Our Ref: 26/00050/PRELB
Contact: Mark Simmons
Direct Line: 01462 474685
Email: mark.simmons@north-herts.gov.uk
Date: 2 March 2026

**Pre-Application Listed Building: Installation of mezzanine floor, secondary glazing, general repairs, and refurbishment.
Methodist Church, Whitehorse Street, Baldock, Hertfordshire SG7 6QB**

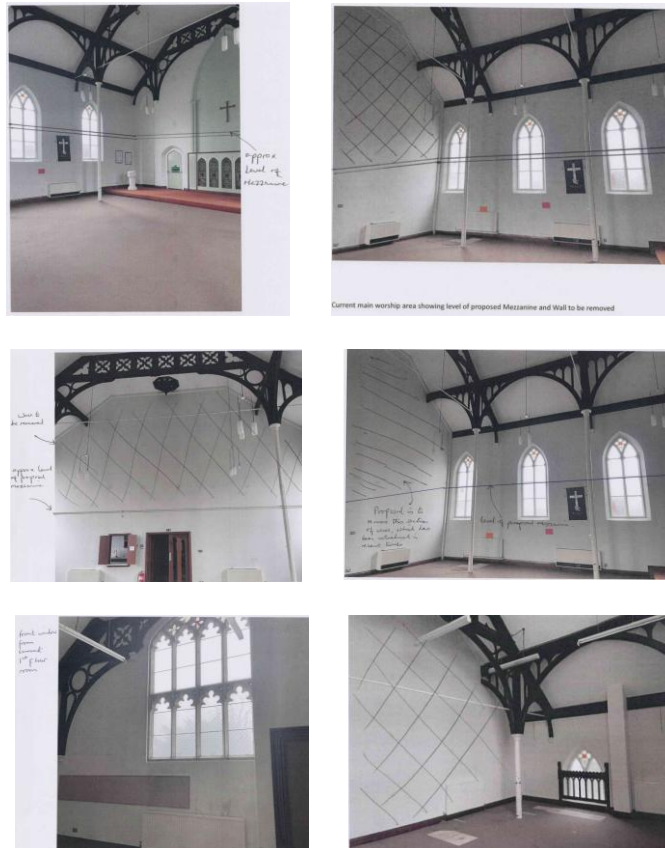
It is noted that the reason why there is no formal determination against app ref: 03/00112/1LB is that the Ecclesiastical Exemption Order applied (see elevation drawing and correspondence below)

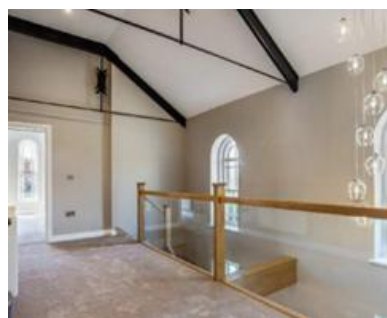
An example as to how the existing first floor visually 'disects' these ground floor windows is expressed in the image immediately above right. Whilst I understand the desire to maximise first floor space and the need to have borrowed light at this level, in my opinion there may be a better way to handle the interface between the floor and windows without having to resort to the visually heavy balustrade treatment. I encourage consideration of a scheme whereby a mezzanine is constructed on the line of metal columns so that the windows are fully expressed at ground floor or possibly something along the lines of the image below.

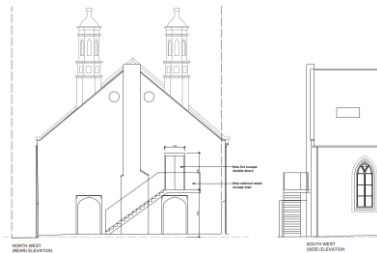
This will require planning permission and listed building consent. The image below refers to this structure possibly incorporating additional toilet facilities thus would not necessarily be fully glazed. This would be located at the front of the listed building and is the most contentious aspect of the current proposal. The proposed reception area (for which no details have been provided) would not only have a significant impact upon the listed building but would also impact upon the character and appearance of the Baldock Conservation Area. It is unlikely that I will be able to support a proposal on heritage grounds.
